Addendum No.: 02

Date Of Addendum: April 12, 2021

DEEP West District Headquarters  
Black Rock State Park  
2065 Thomaston Rd, Watertown, CT  
BI – T – 615

The following clarifications are applicable to drawings and specifications for the project referenced above.

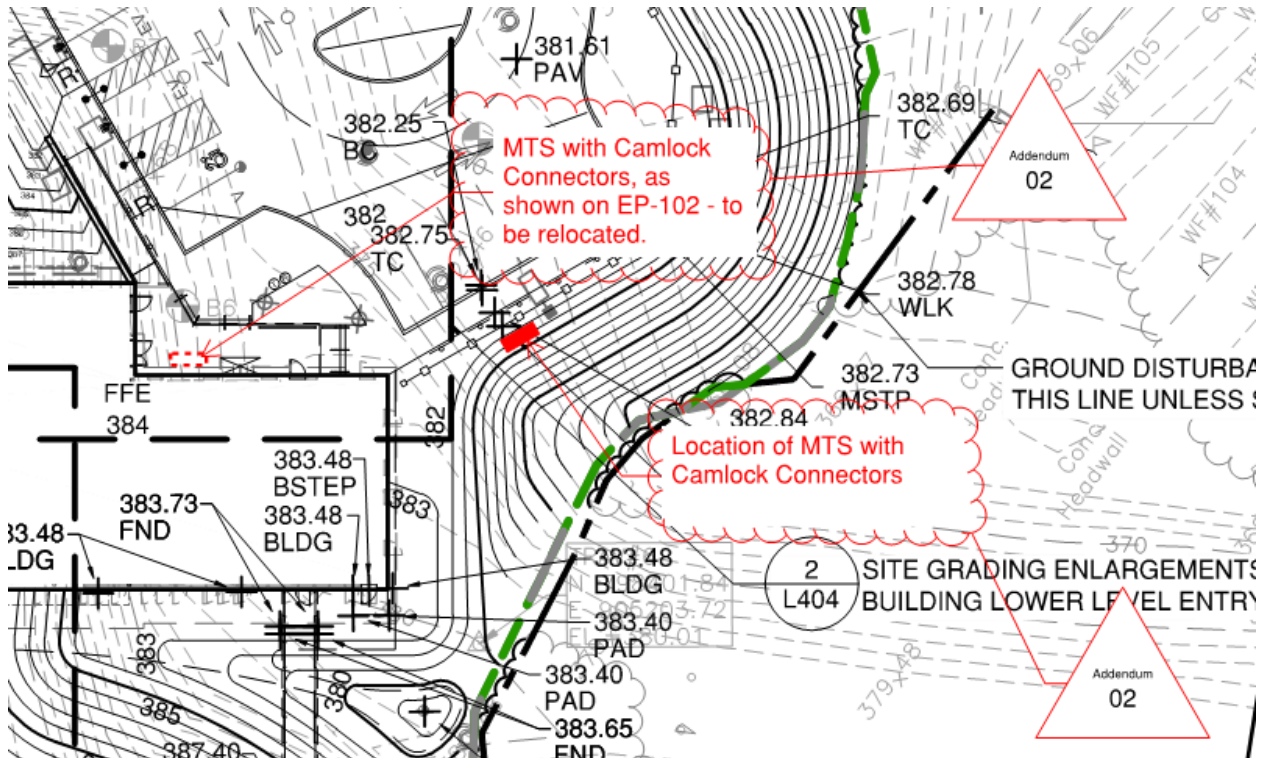
29. Location of main building Camlock backup – Drawings show the MTS for the camlock backup system on the lower level patio of the north side of building and also calls for it to be mounted to side of building. Spec'd out MTS is not wall mount for a 1000A rated, it's a pad mount and it is not very good looking, it looks like

switchgear. Would like to confirm that's where it is going.

**Response:** The MTS for the Camlock backup shall be relocated to the south side of the lower parking lot. Provide 2-foot thick concrete pad on 12" crushed stone to accommodate grade change. Extend conduit through new pad to MDS. Location to be as follows (Note drawing excerpt from Drawing L104; also reference drawings EP-102, SE-1 and Civil Drawings):

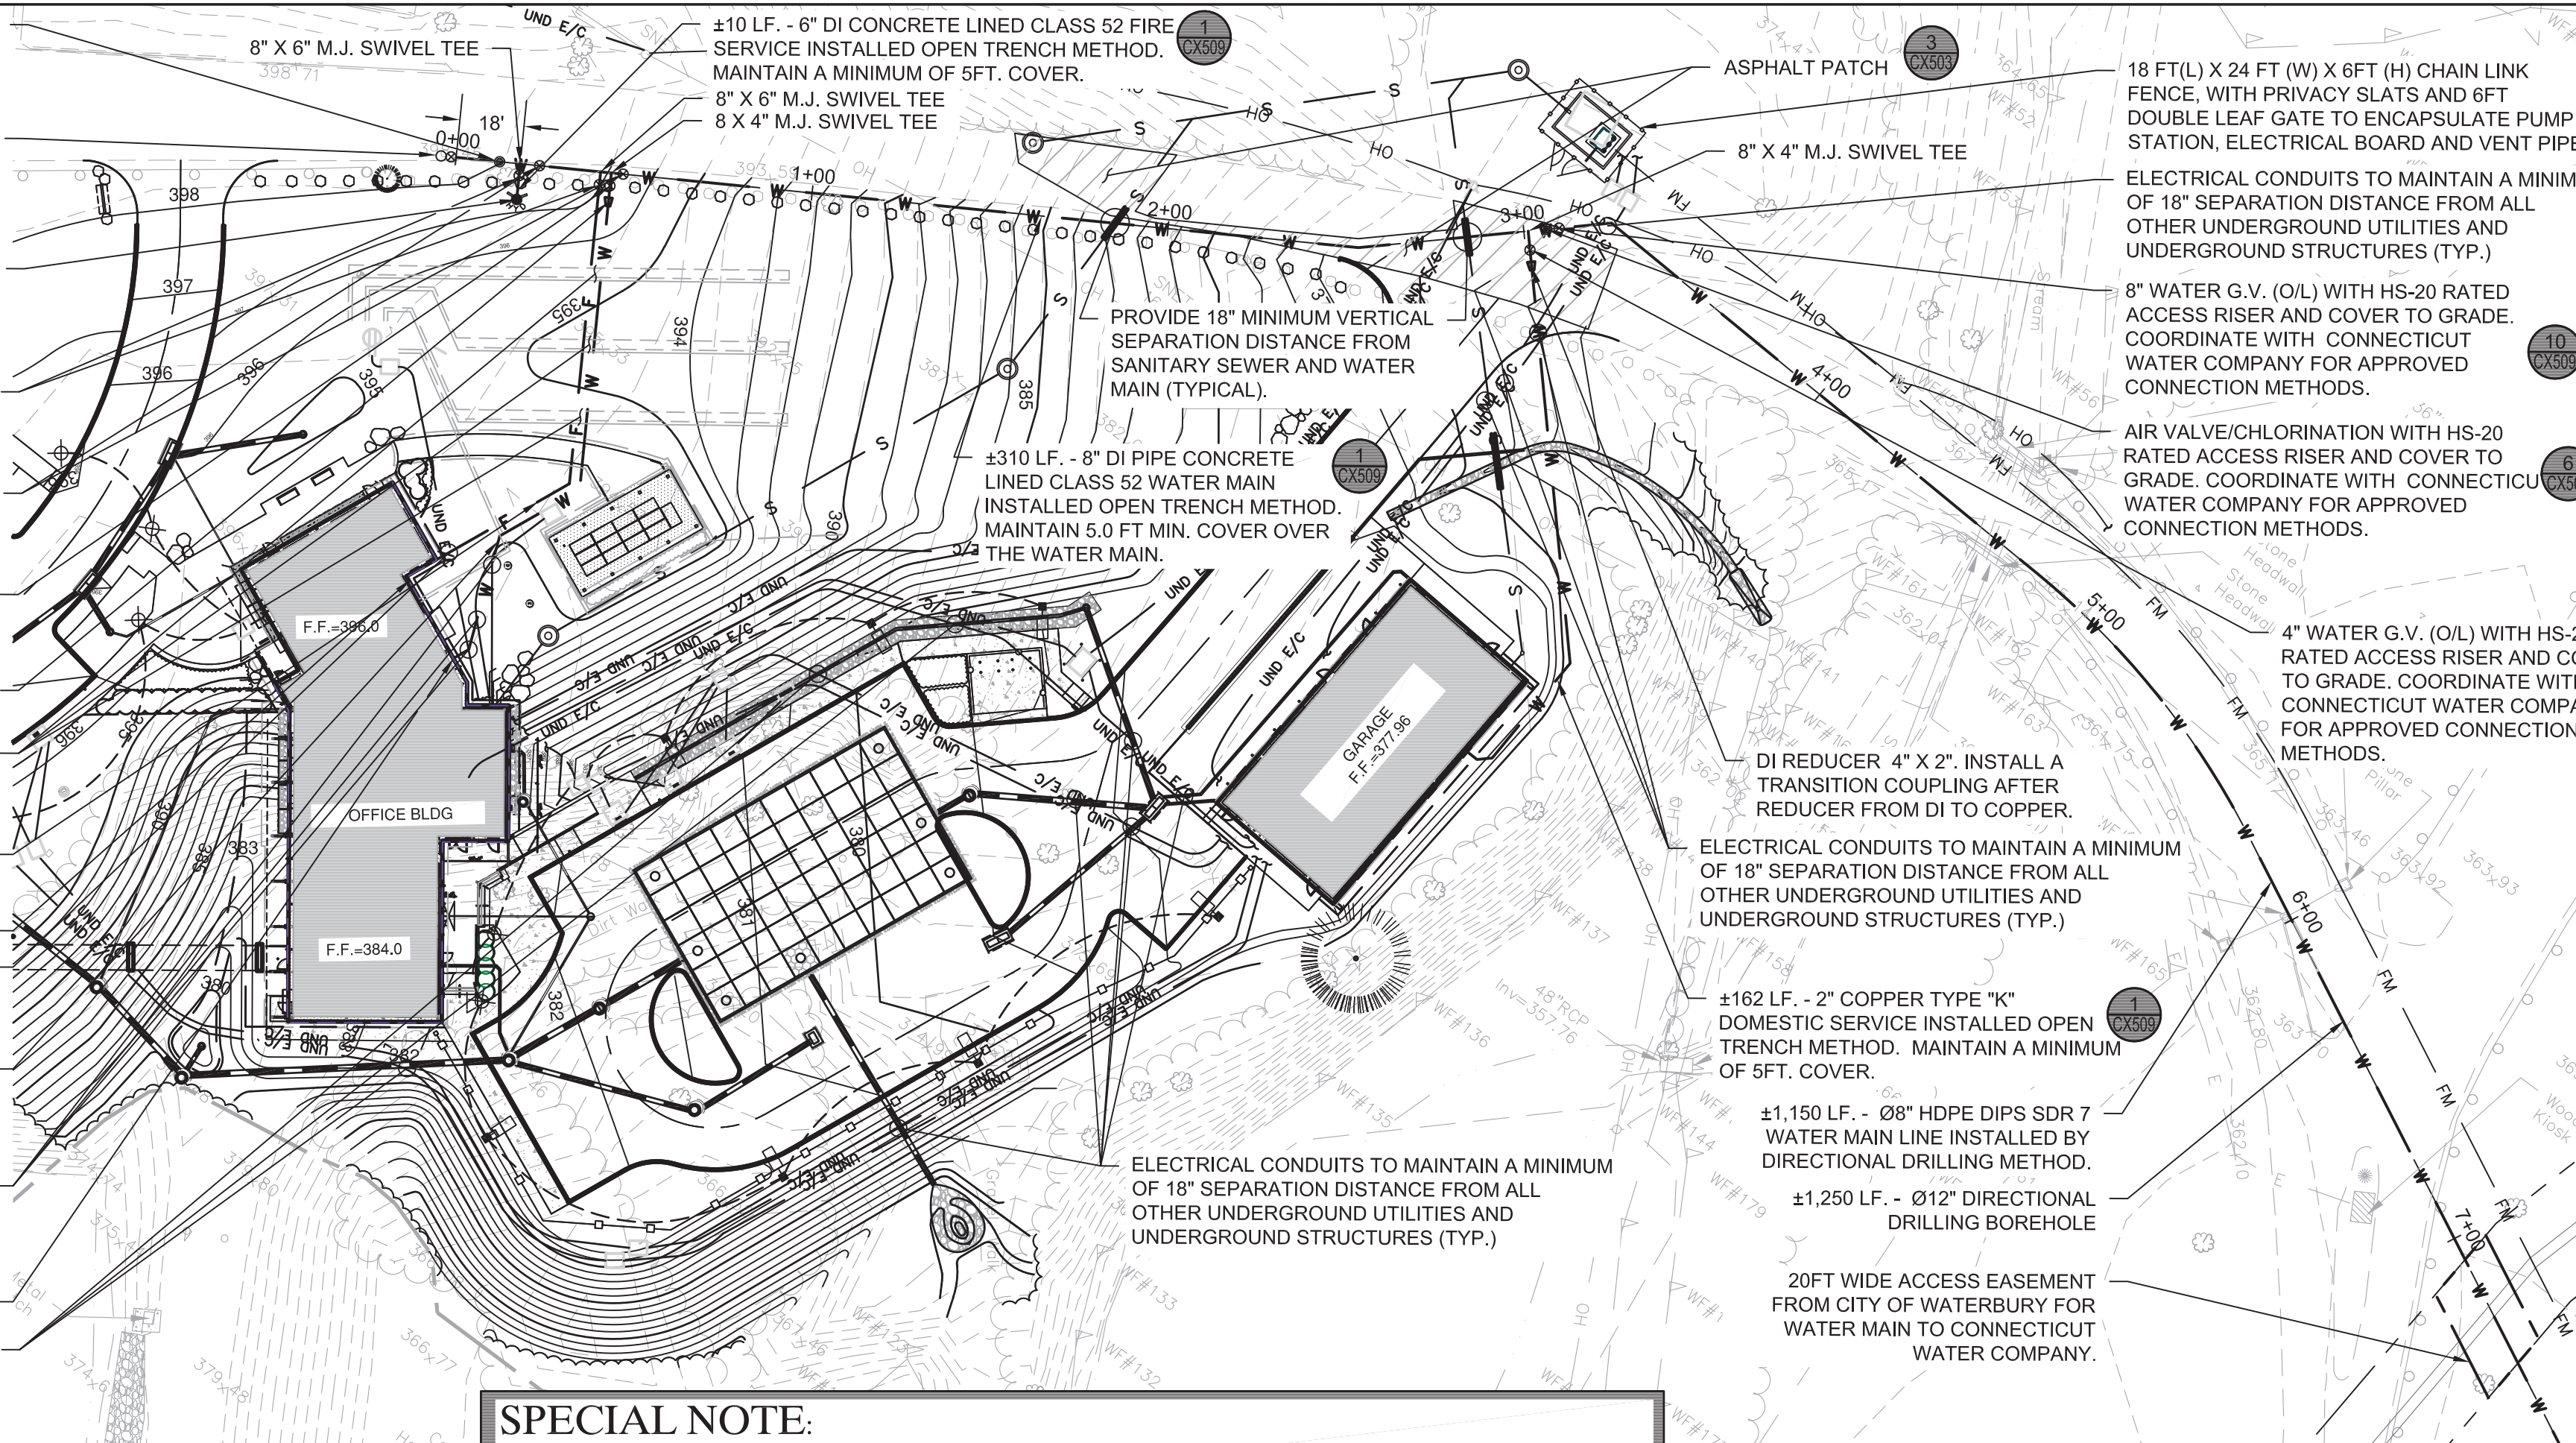
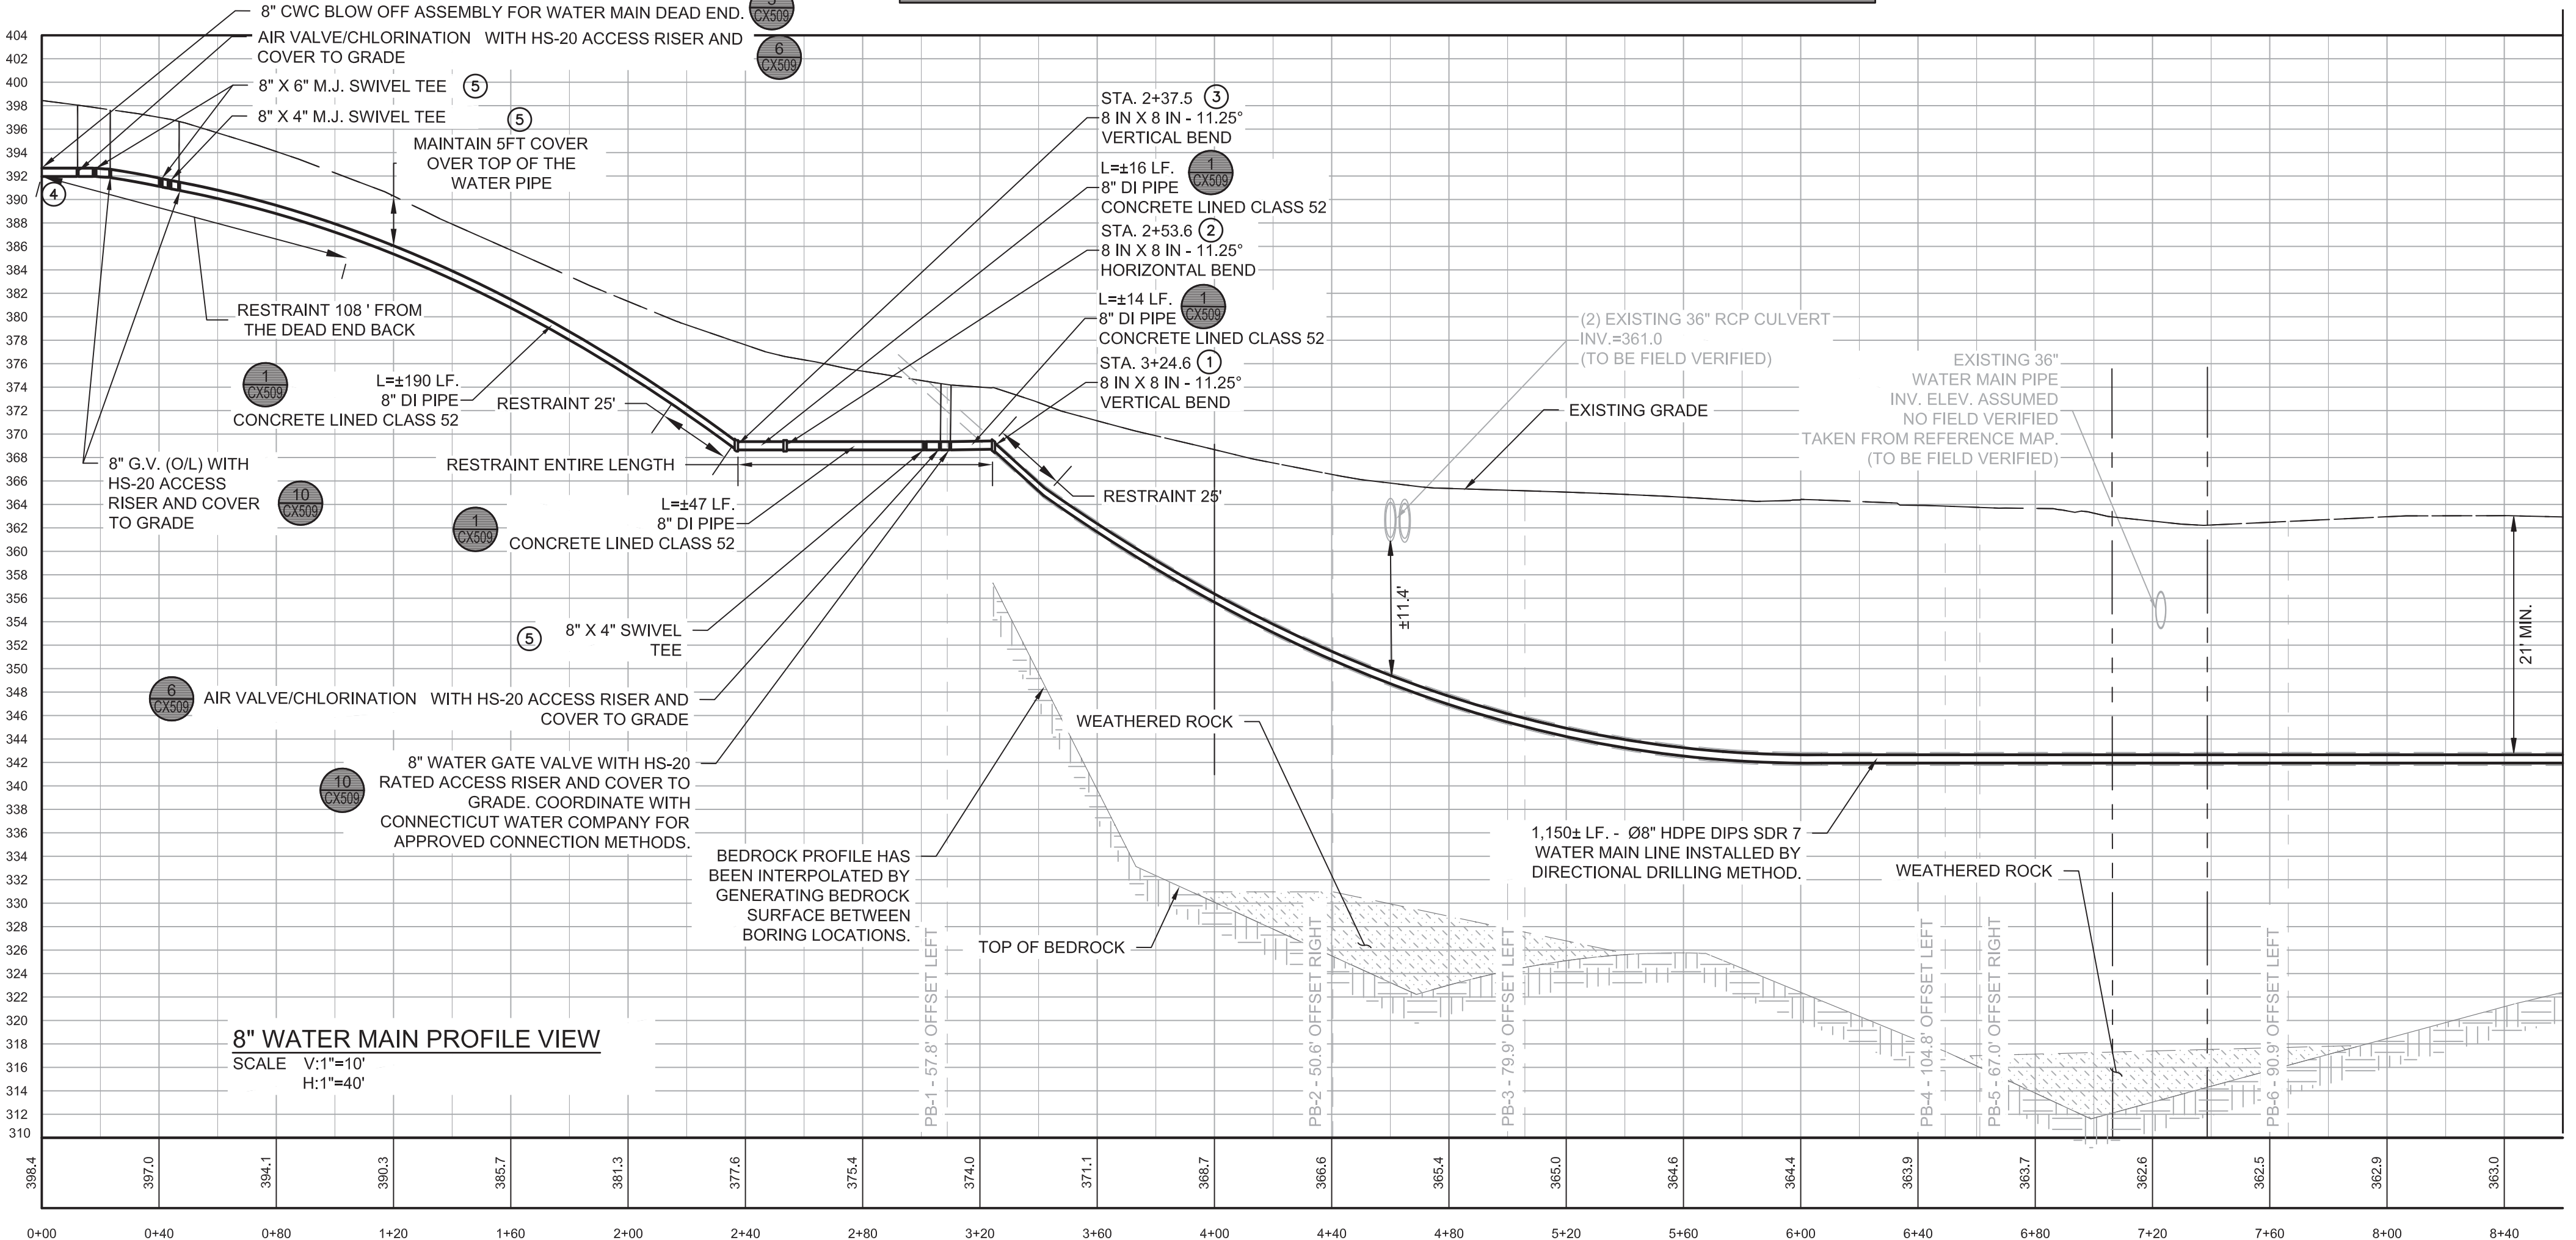
A. Drawing CU-101:

Add Note: "Ensure minimum 24" Vertical Separation distance is maintained between top of water piping and bottom of Geothermal Pipe trench bedding. See Detail 2 on Sheet SU-1"

- ENSURE 24" VERTICAL SEPARATION DISTANCE IS MAINTAINED BETWEEN TOP OF WATER PIPING AND BOTTOM OF GEOTHERMAL PIPE TRENCH BEDDING. SEE DETAIL 2 ON SHEET SU-1.
